# College of Marin Facilities Master Plan and Learning Resources Center

Final Environmental Impact Report

SCH #2019110285

**June 2020**

### Fault Proximity

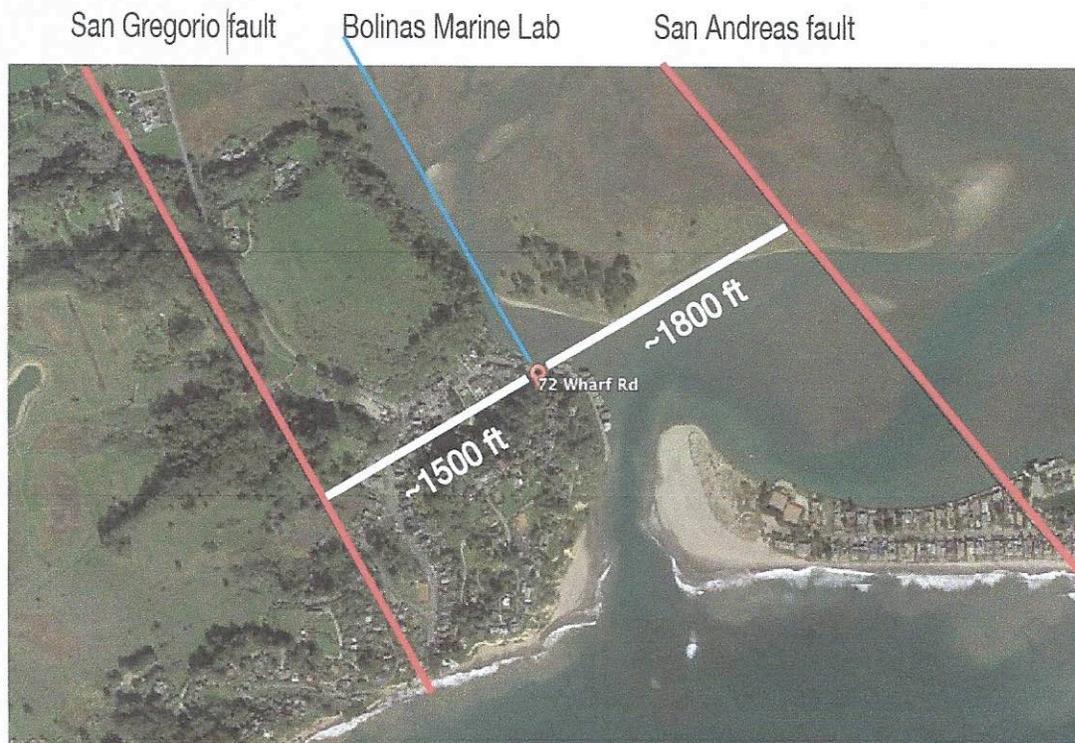
The property at 72 Wharf Rd. (indicated by green star) appears to lie within a zone affected by the 1972 Alquist-Priolo Act (indicated in yellow), which delineates zones requiring a geologic investigation by a licensed geologist prior to construction permitting. In general, when a fault is discovered on the property, building is not allowed within 50 feet of the fault. (<https://www.conservation.ca.gov/cgs/Pages/Earthquakes/disclose.aspx>)

### **Tsunami Inundation Zones**

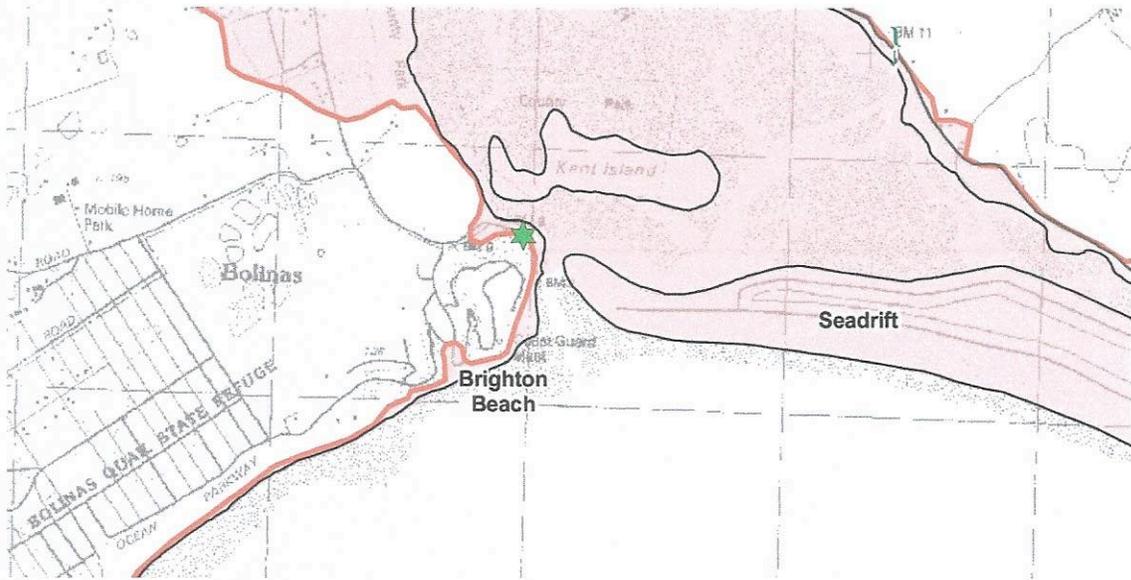
According to the mapping listed above, the 72 Wharf Rd. site (green star) appears to be on the edge of the tsunami inundation zone, as shown in this map:

However, this site is not unique in its proximity to the tsunami inundation zone, nor is it the only community college affected by this issue.
